## ADDENDUM NO. 2

Reference: New Hurricane Liquor and Wine Store  
Department of Alcoholic Beverage Control  
DFCM Project No. 08228030

**Addendum No. A02**

**New Hurricane, UT Liquor Store  
Department of Alcoholic Beverage Control  
Hurricane, Utah  
DFCM Project No. 08228030**

**A 101**

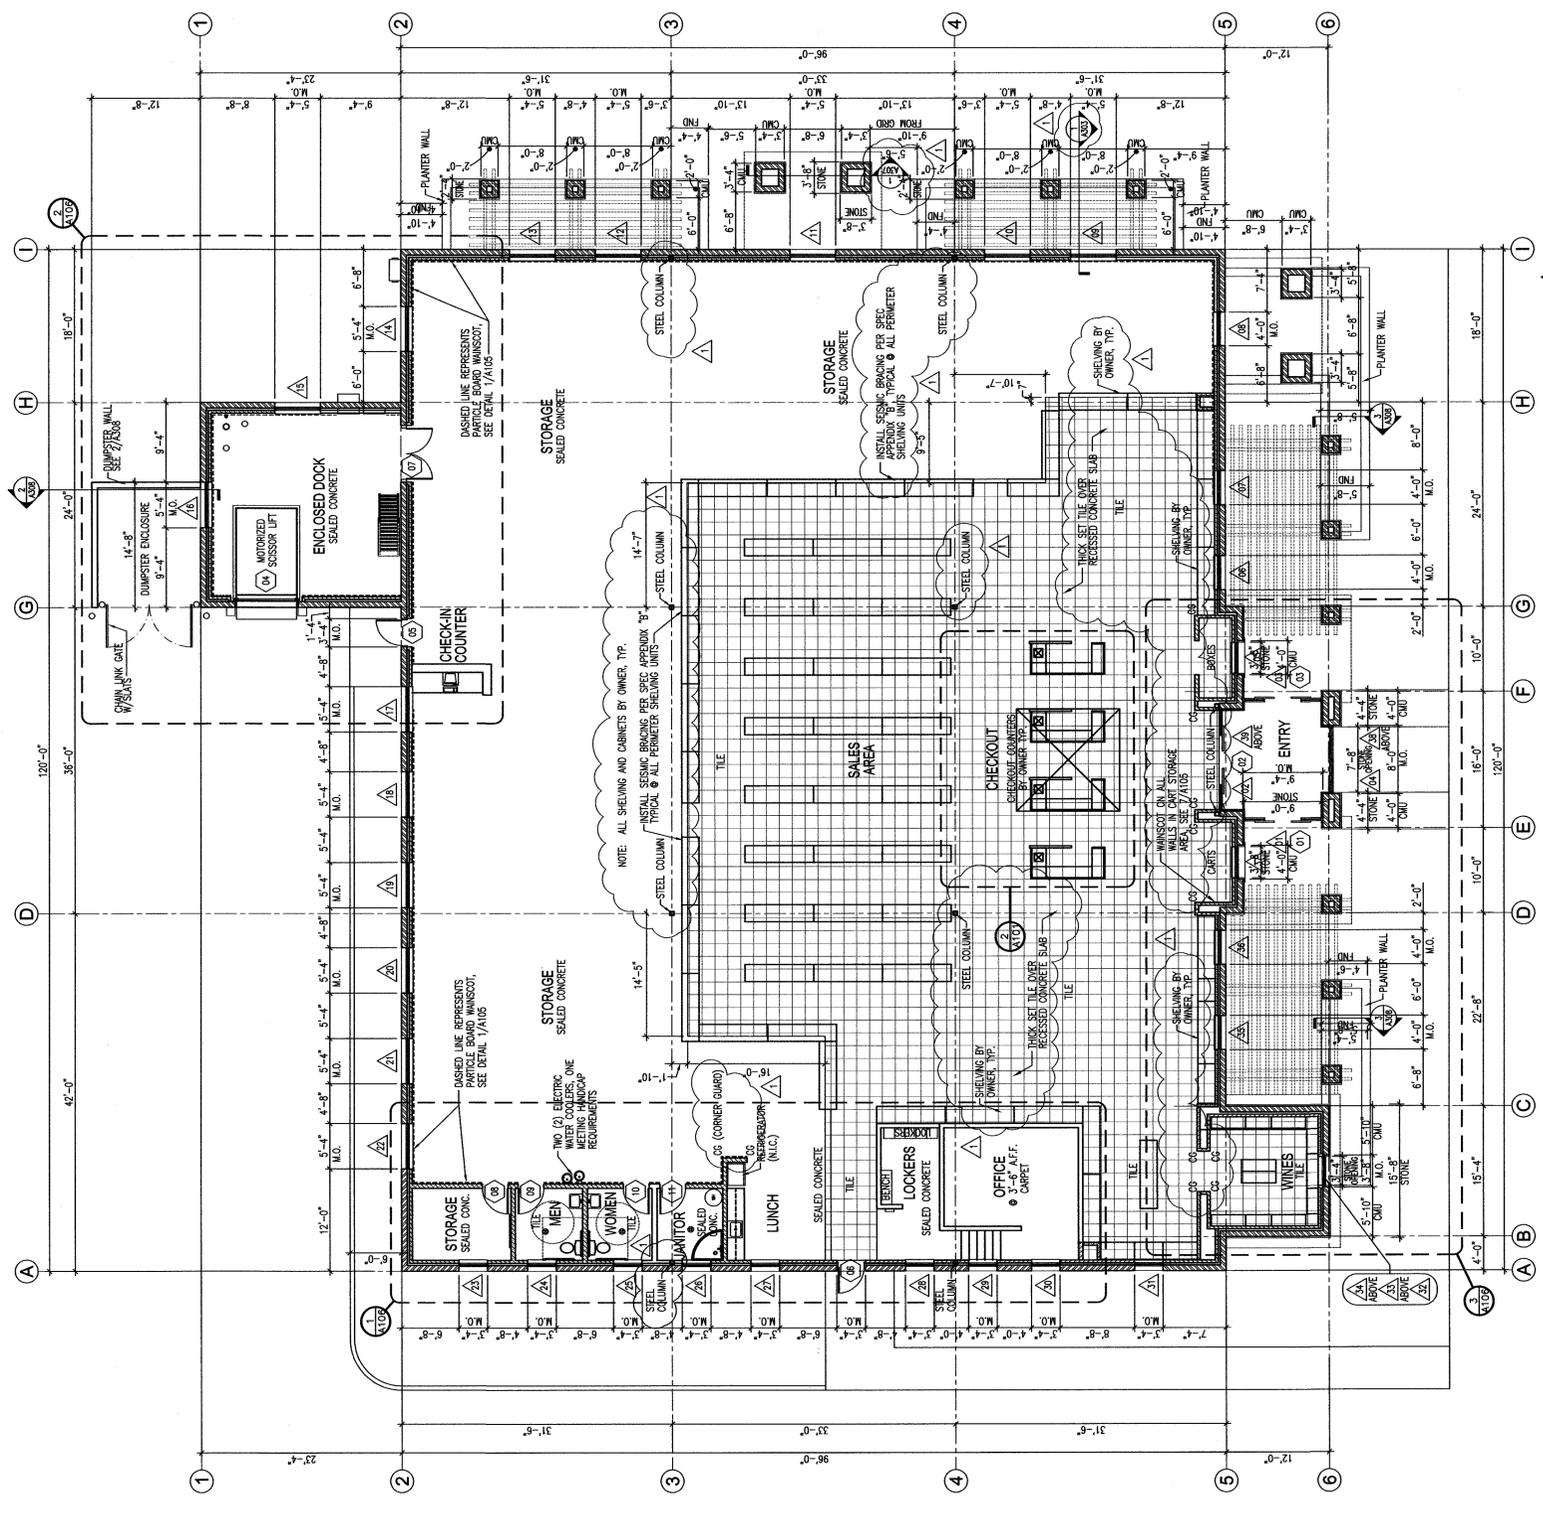
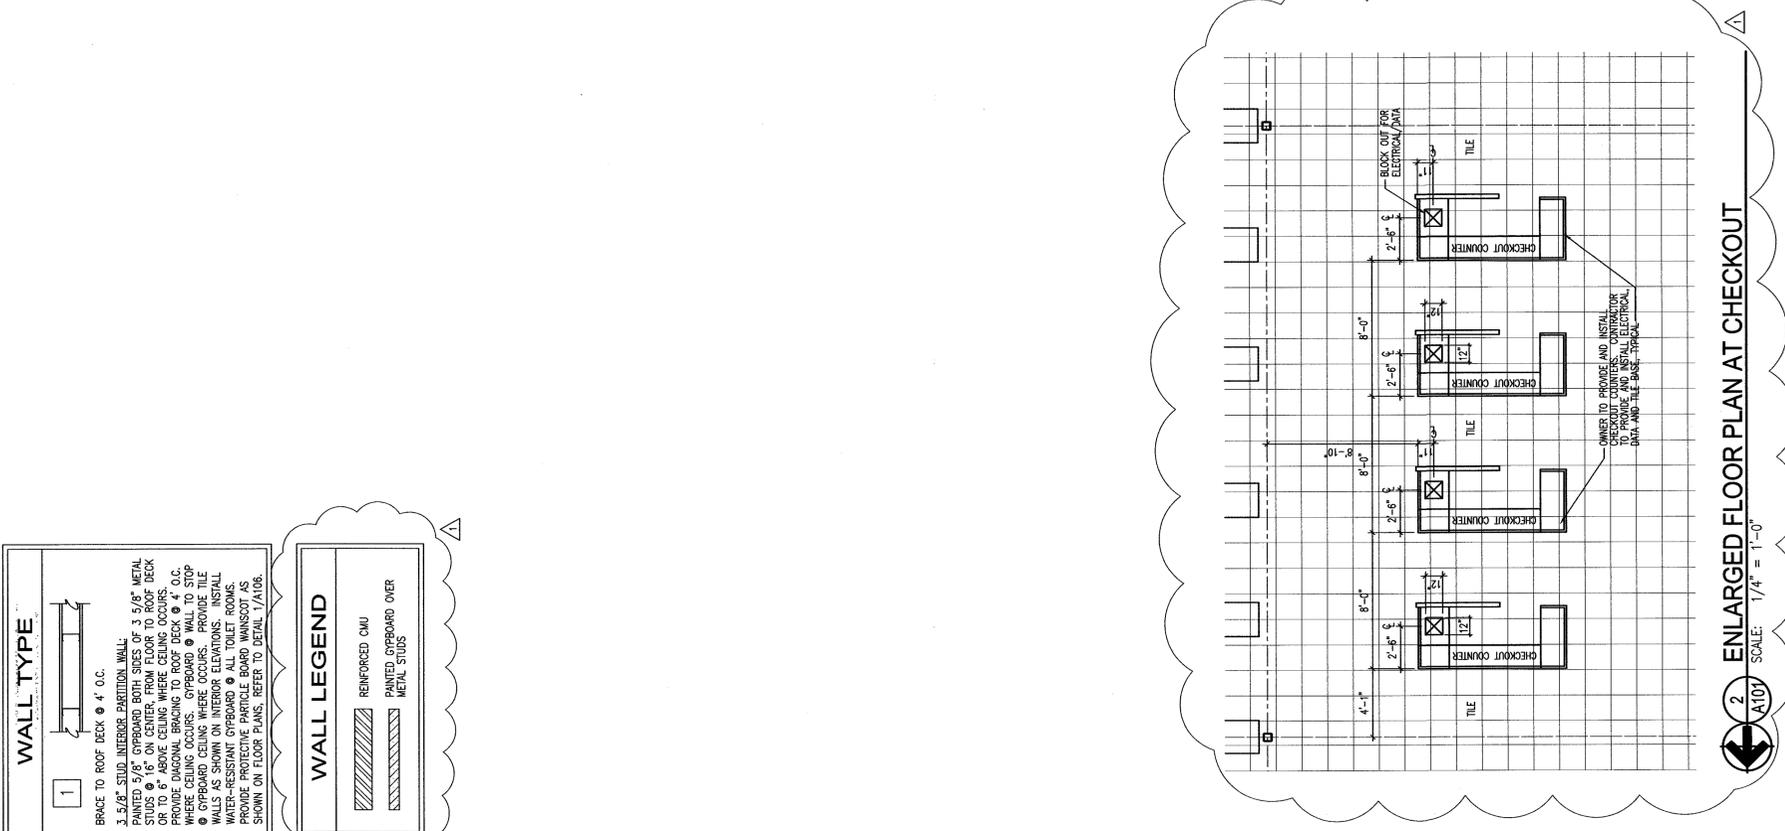
2. **Sheet A101: Sheet A101 is reissued with the following changes:**
  - a. A "Wall Legend" has been added to the sheet.
  - b. 2/A101, an enlarged floor plan at the checkout counters, has been added to the sheet and is referenced on 1/A101.
  - c. Additional notes have been added to 1/A101, including notes regarding shelving, seismic bracing for shelving, corner guards, floor tile and steel columns.
  - d. The section tag located on Grid "I", between Grids "4" and "5" should be designated as 1/A303 instead of 1/A308.
  - e. Section tag 1/A307 has been added at the CMU piers located between Grid "3" and Grid "4"

WALL LEGEND ADDED. ENLARGED FLOOR PLAN 2/A101  
 FLOOR AND STEEL COLUMNS ADDED TO 1/A101.  
 SECTION TAG AT GRID 1 BETWEEN GRIDS 3' AND 5'  
 AT CMU PIER BETWEEN GRIDS 3' AND 4'.  
 SECTION TAG AT GRID 1 BETWEEN GRIDS 3' AND 4' ADDED
